RE: **Blythe Solar Power Project, Docket No. 09-AFC-6**
Responses to January 14, 2010 CEC Workshop Queries
Technical Areas:
Soil & Water Resources (supplemental data for DR-S&W-218)

**Soil and Water Resources
(Supplemental Data for DR-S&W-218)**

Blythe Solar Power Project
Docket No. 09-AFC-6

Soil and Water Data Responses to January 14, 2010 CEC Workshop Queries

Kiewit Power
9401 Renner Boulevard
Lenexa, Kansas 66219

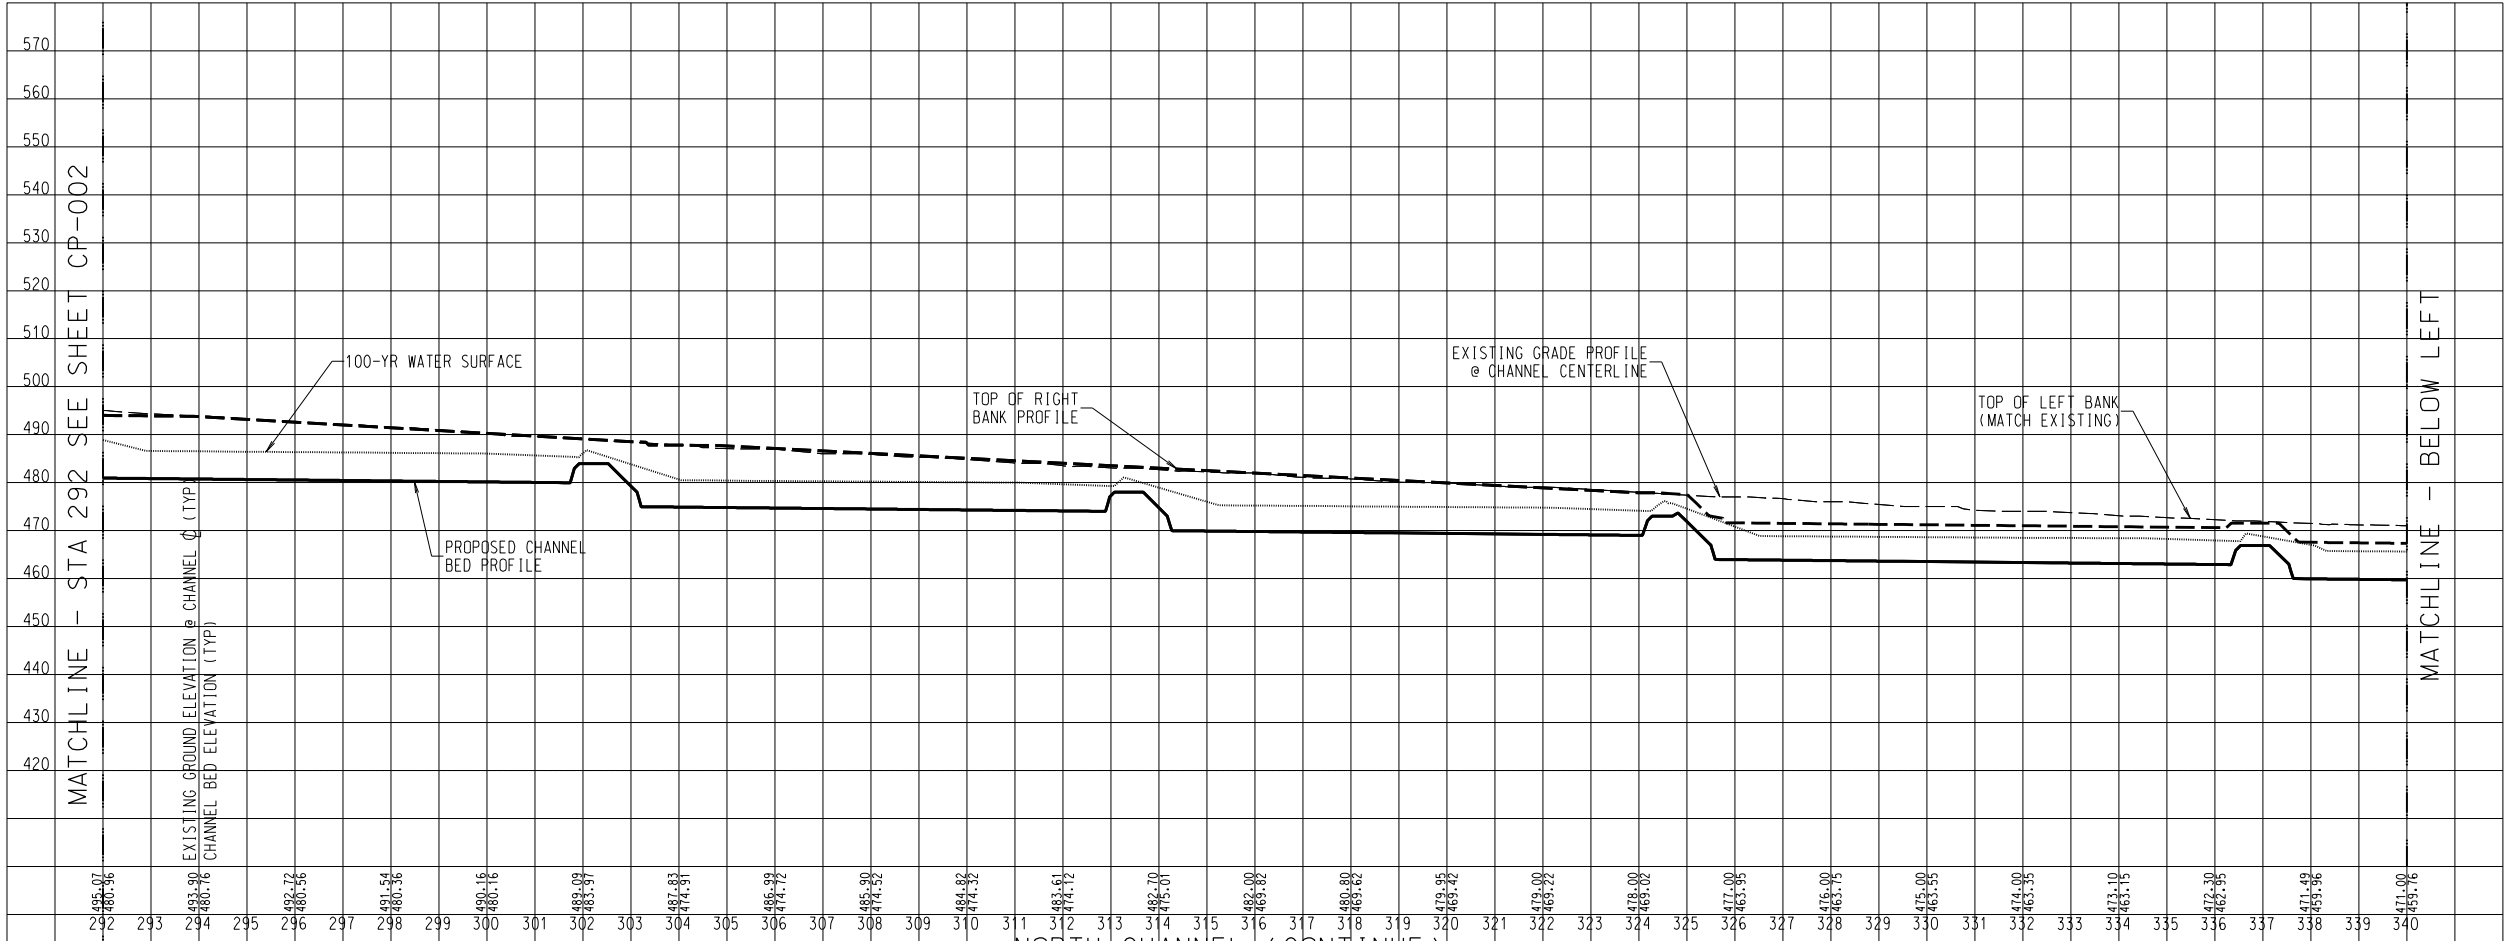
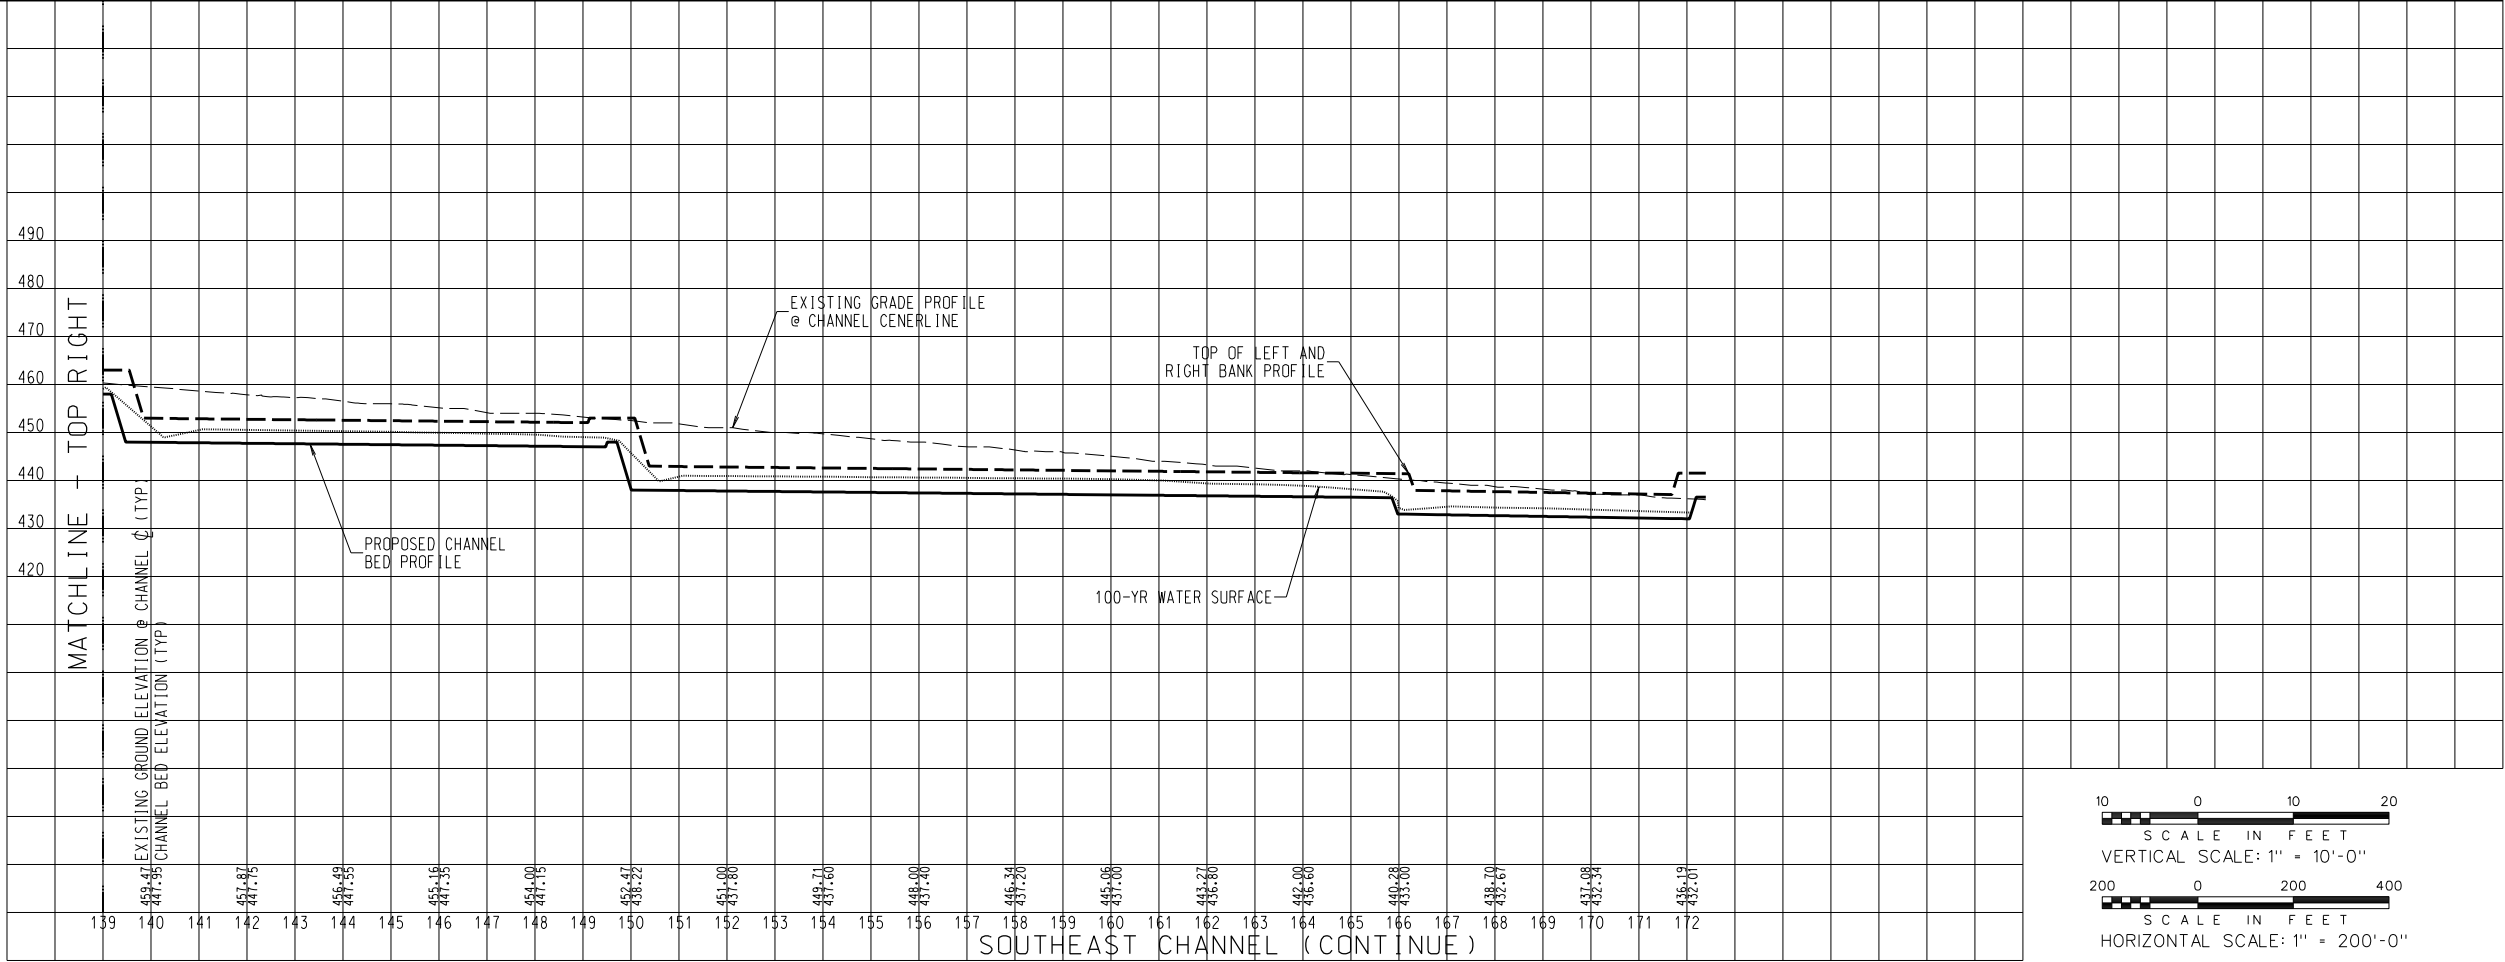
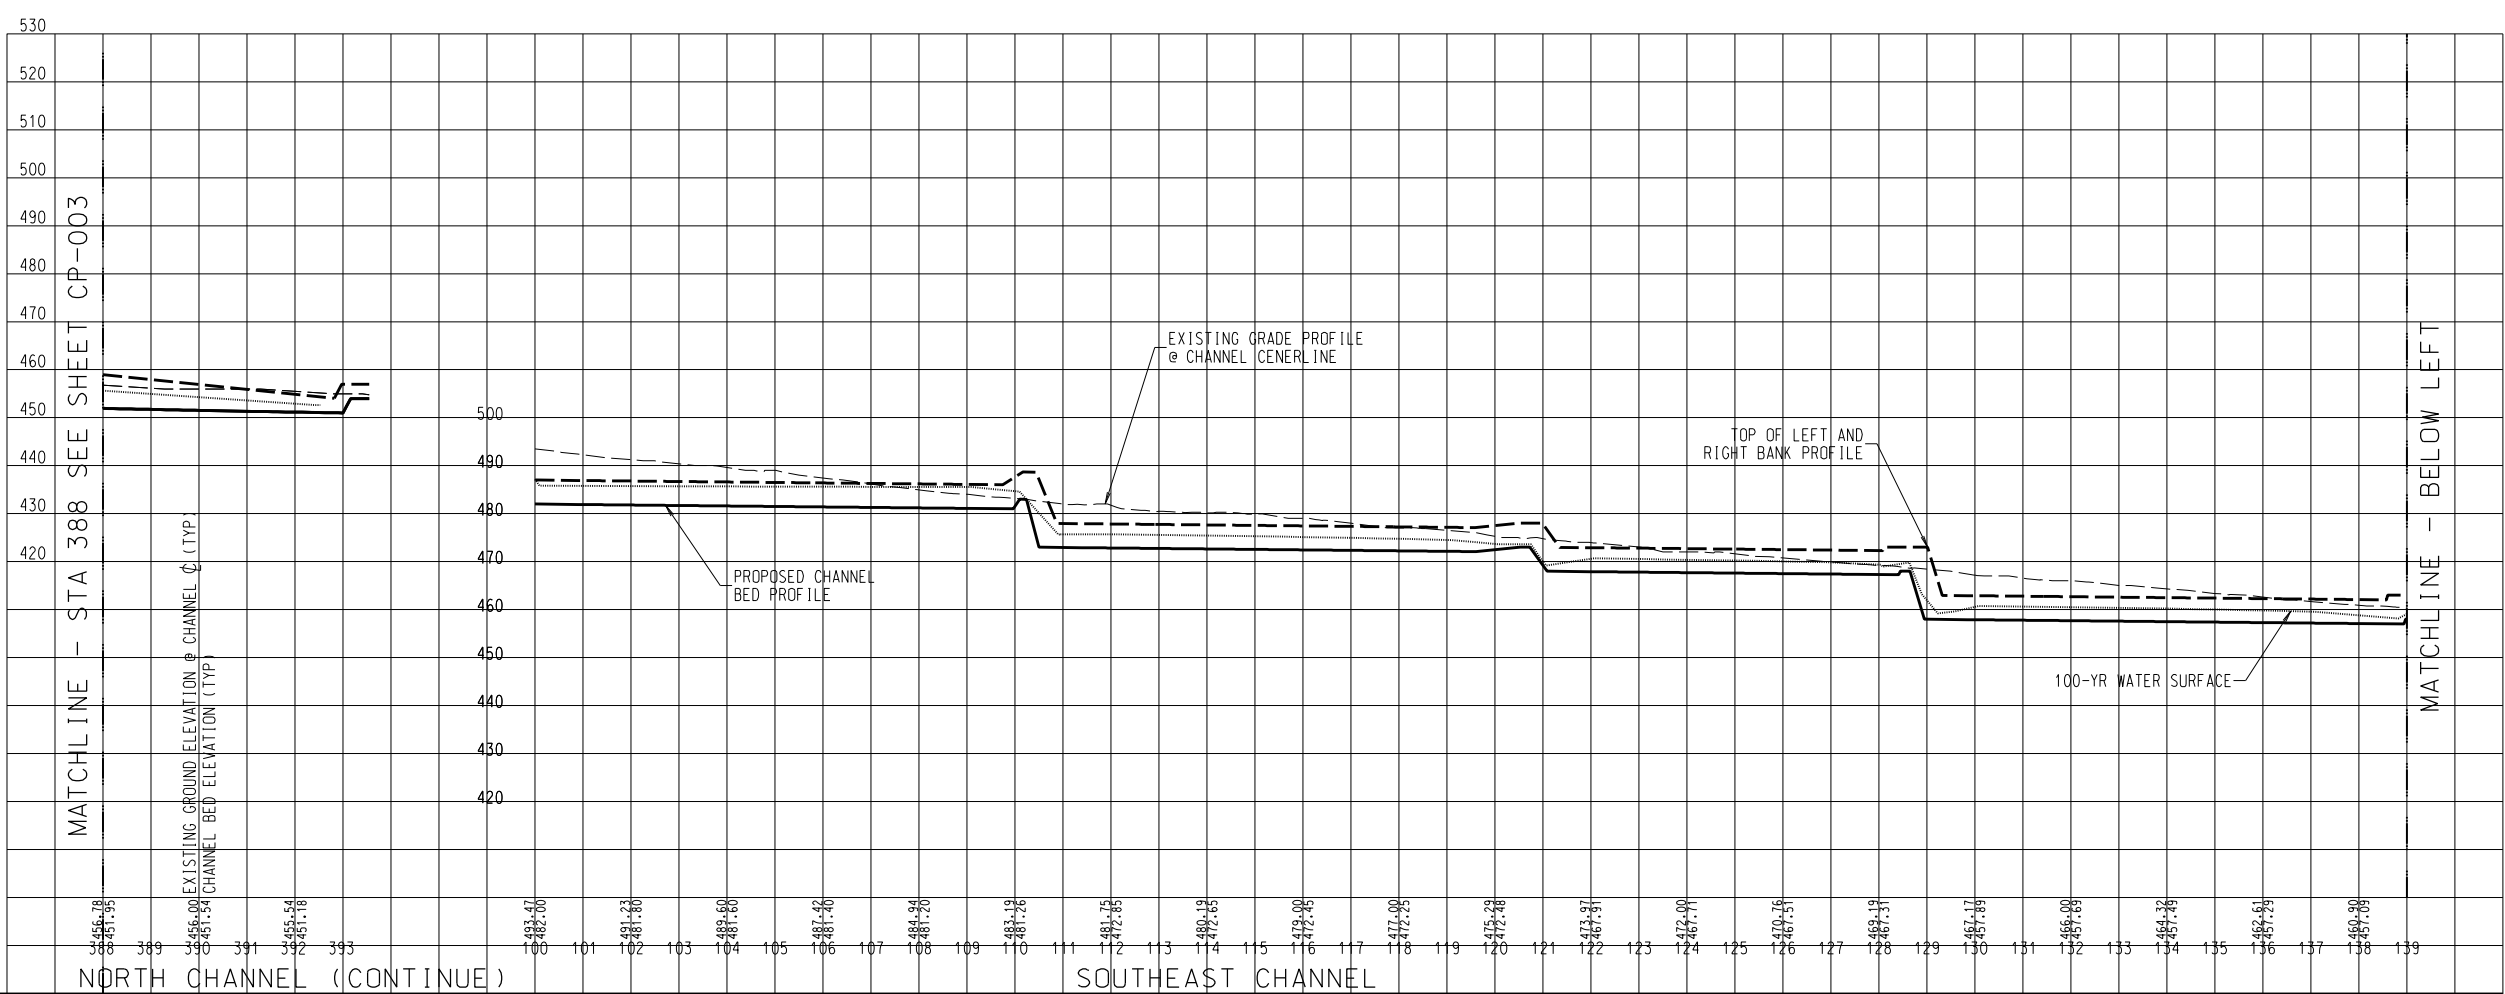
Add 100-yr. water surface elevations on profiles for main channels (both collectors and conveyance).

The 100-year water surface profile has been added to the plans and is provided on Sheets CP-001 to CP-009 as part of this response.
